TECHNICAL INFORMATION

- Subject** ▶ Change in the Method of Attaching Ball Bearing 626DDW to Armature Shaft, and Modification of Housing Set
- For Models** ▶ BHR200
- Country** ▶ All countries
- Description** ▶
 1. The method of inserting the ball bearing to the armature shaft has been changed. Accordingly, the part number of the Armature Assembly has been changed.
 2. The Housing Set has been modified as illustrated below in order to accept the new Armature Assembly.

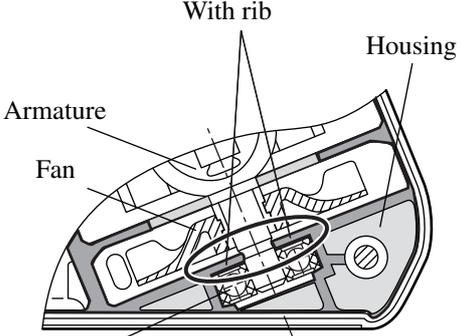
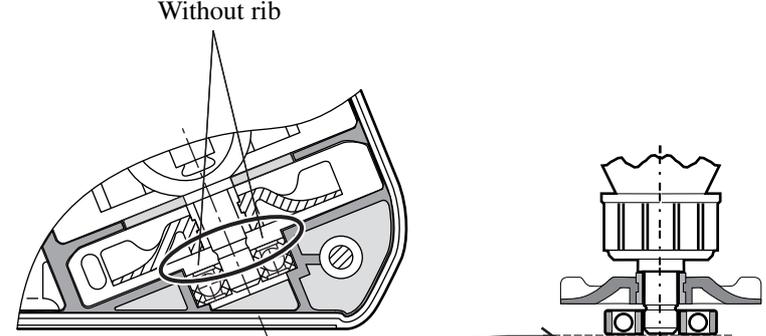
▶ Current	▶ New
<p style="text-align: center;">With rib</p>  <p style="text-align: center;">Ball Bearing 626DDW</p> <p>Armature Assembly is inserted into Ball Bearing 626DDW with gentle pressure.</p>	<p style="text-align: center;">Without rib</p>  <p>The armature shaft is machine-pressed into the ball bearing 626DDW.</p>

Item No.	Current part	Q'ty	I/C	New part	Q'ty	Note
062	Armature Assembly 24V 519060-6	1	No	Armature Assembly 24V 519066-4	1	1. Interchangeable as a set of the armature assembly and the housing set. 2. The new housing set comes with a Makita logo label.
050, 088	Housing Set 183247-2	1	No	Housing Set 183393-1	1
